Superlon Plastics Co. Inc. Site Ditch Interim Action Work Plan Responsiveness Summary

*Ecology's response to public
comments*

July 2021

Figure 2. The planned excavation area for removal of arsenic- and lead-contamination from the drainage ditch and berm soil at and near the Superlon site.

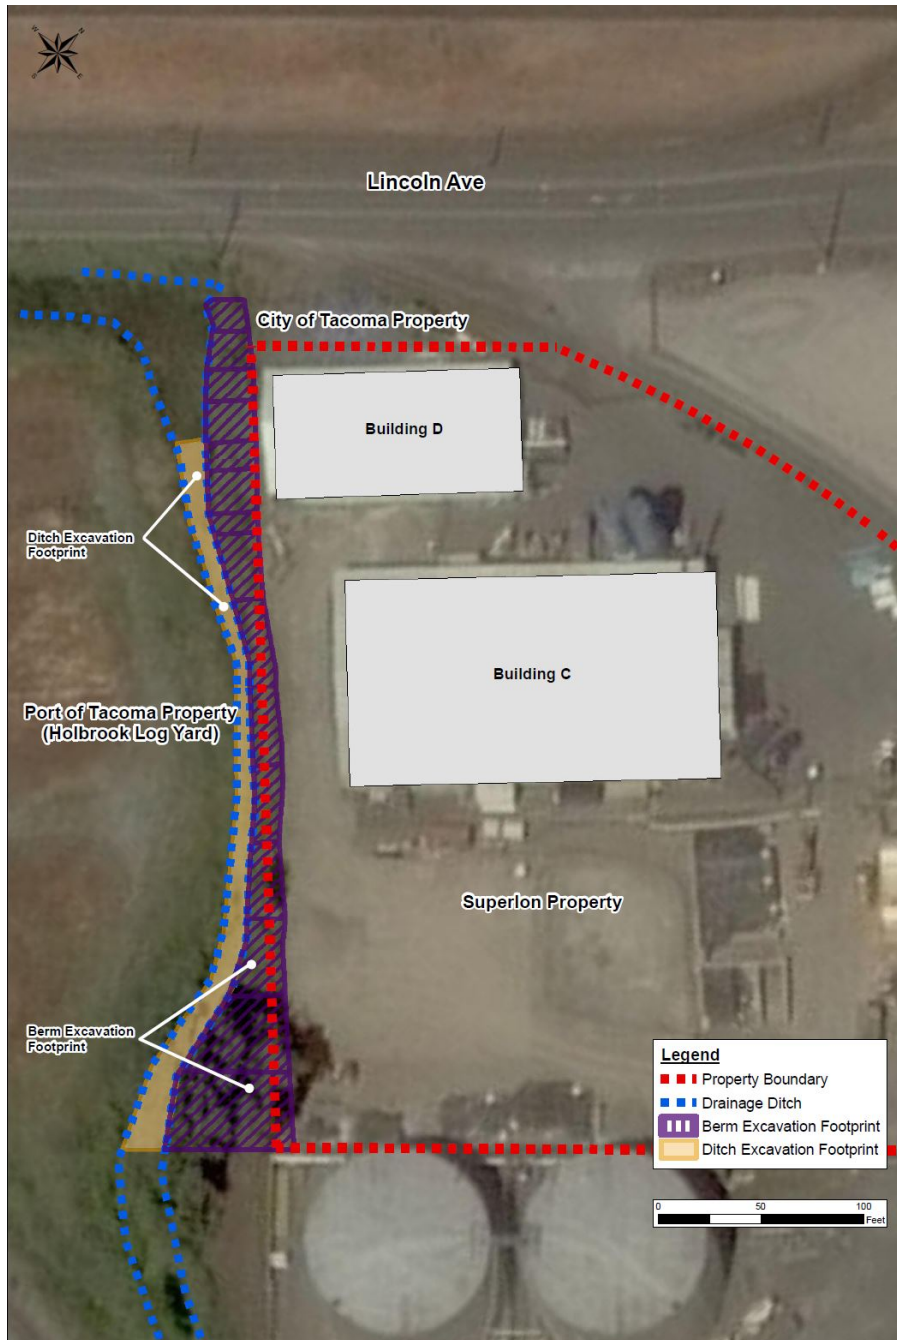
EPA Comment	Ecology's response
<p>31. Figure 2: What does this mean? How will initial excavation depth be determined for a given RAU or individual EUs, esp in the field?</p>	<p>The initial excavation depth for a RAU is identified on Figure 2 in the IAWP. The initial excavation depth was based on data collected from the sidewalls of excavation at the top of the berm on the property (see Table 4, IAWP). Samples from the bottom of the excavations within each trench box will be analyzed at the on-site lab to confirm when remedial goals are met (see Section 5.2.5.2).</p>
